Special Documentation

DipFit W CPA530

Important information on dimensions

A0056619

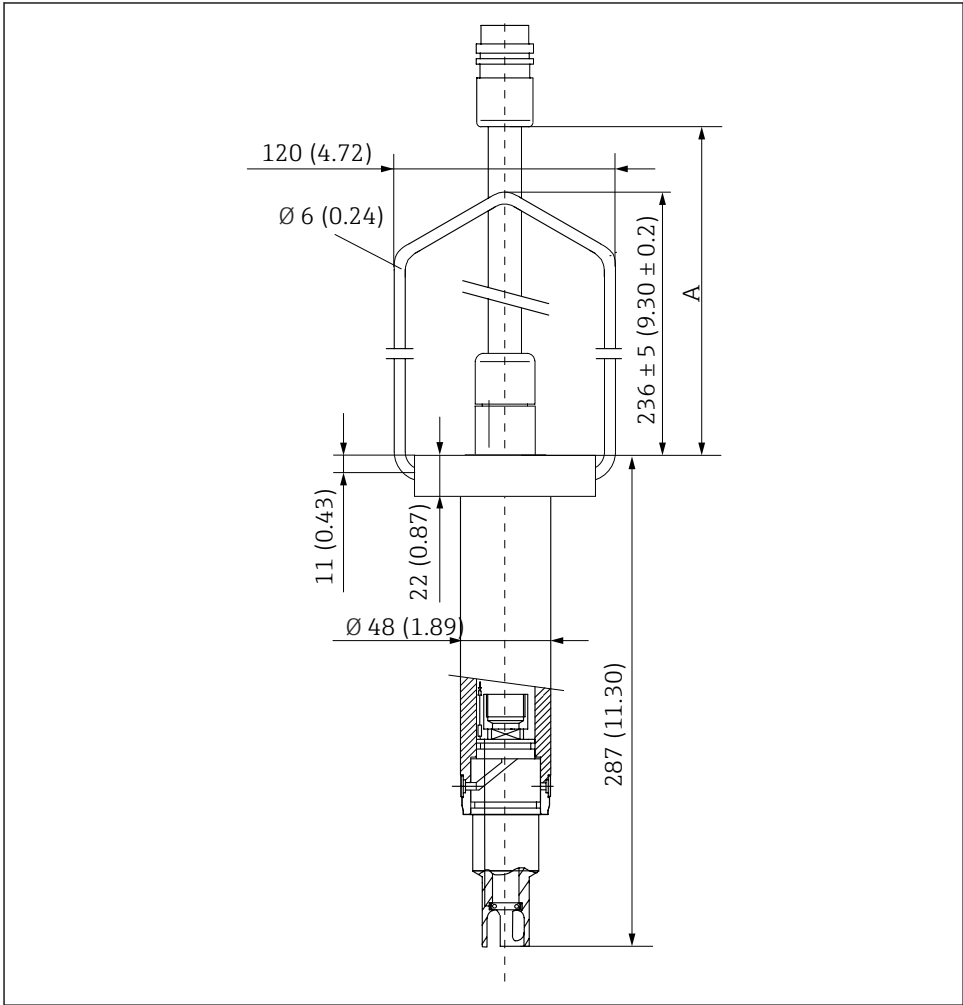
Unfortunately, we have to inform you that the given dimensions in the following drawings are incorrect:

- In the Operating Instructions BA 018C No. 50043898, figure BA018Y11.CDR
- In the Technical Information TI 018C No. 50043901, figure PA530T03.CDR

► The correct dimensions are shown below

1 dimensions. Unit of measurement mm (in)

A Length of the PVC hose
